**TRANSMITTAL – OPERATIONS AND MAINTENANCE PLAN FOR THE
NORTHWEST STORMWATER CONTROL FACILITY AT THE PADUCAH GASEOUS
DIFFUSION PLANT, PADUCAH, KENTUCKY (DOE/OR/07-2044&D1/R3)**

Comment Response Summary

for the
Operation and Maintenance Plan
for the Northwest Storm Water Control Facility
at the Paducah Gaseous Diffusion Plant, Paducah, Kentucky
(DOE/OR/2044&D1/R2)

**Operation and Maintenance Plan for the
Northwest Storm Water Control Facility at the
Paducah Gaseous Diffusion Plant,
Paducah, Kentucky**

Fig. A.4. Relationship of NTU to TSS in samples collected from the C-613 Basin (March through May 2003).

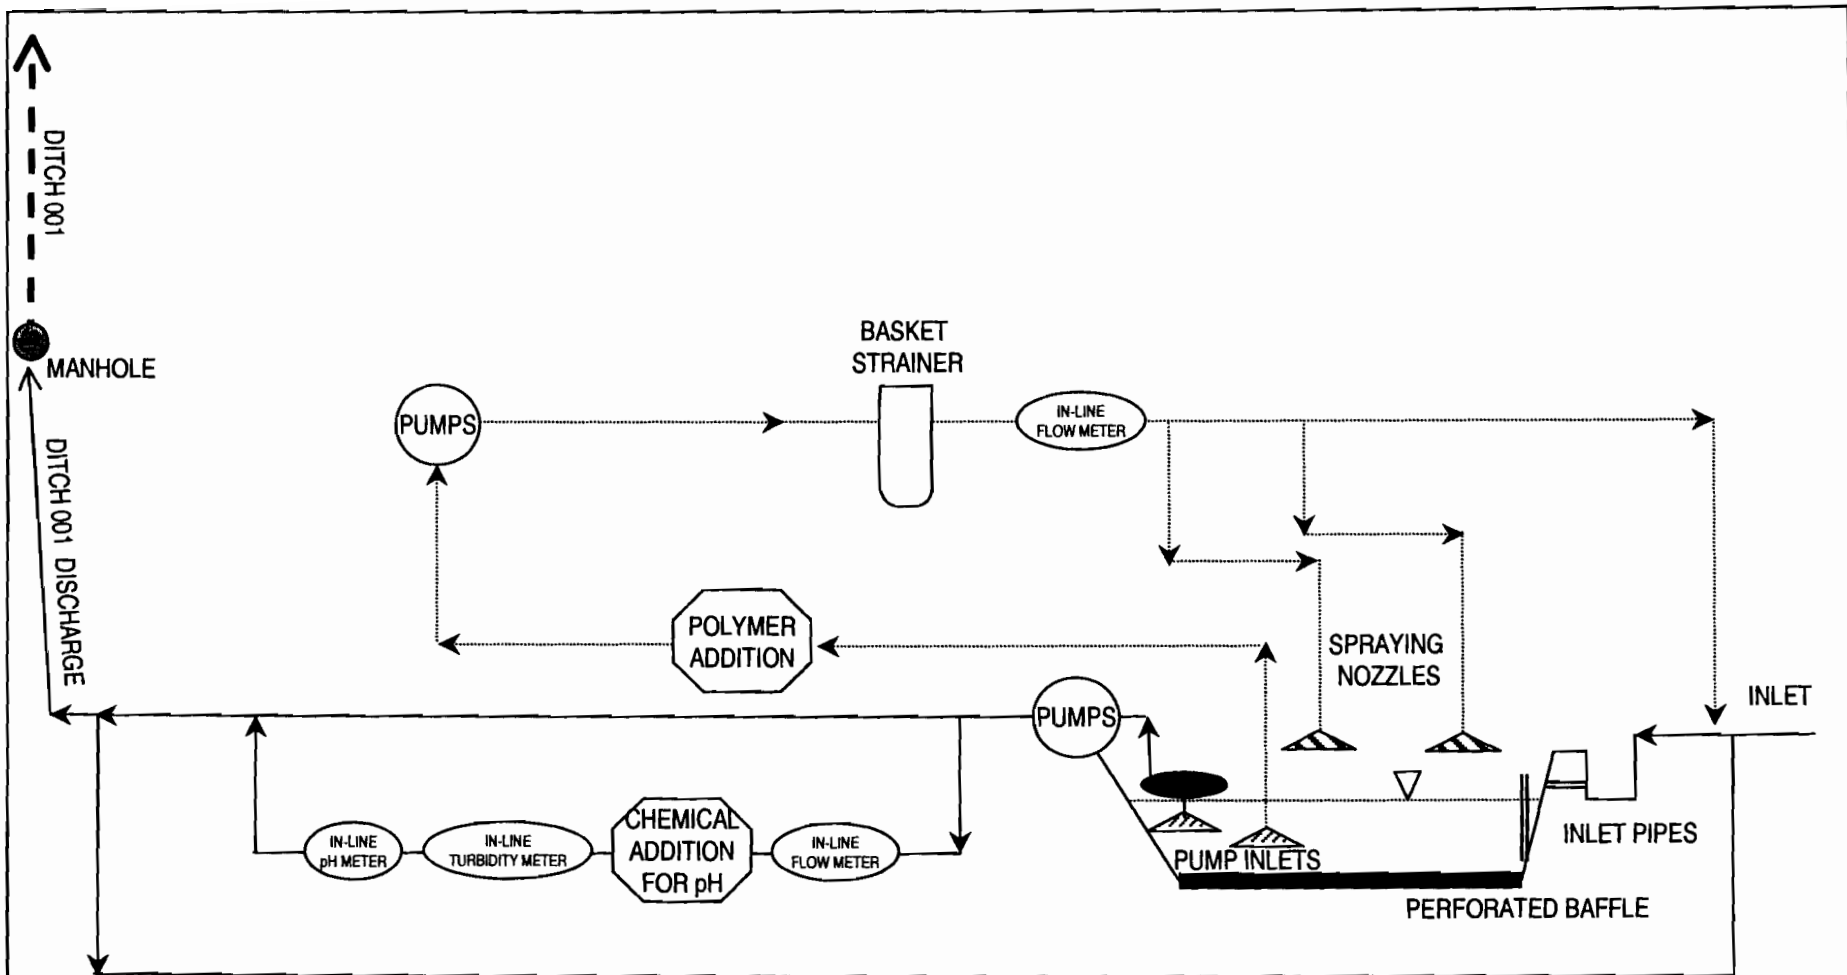
5.	Specific Comment #3, Figure A.4 – Relationship of NTU to TSS in samples collected from the C-613 Basin , Page A-5	KDEP: <i>“In the legend, please define the terms TSS and NTU and include the quarterly TSS sample collection date.”</i>	Agree. The terms are defined on the figure. The figure title now reads: <i>“Relationship of NTU to TSS in samples collected from the C-613 Basin (March through May 2003).”</i>
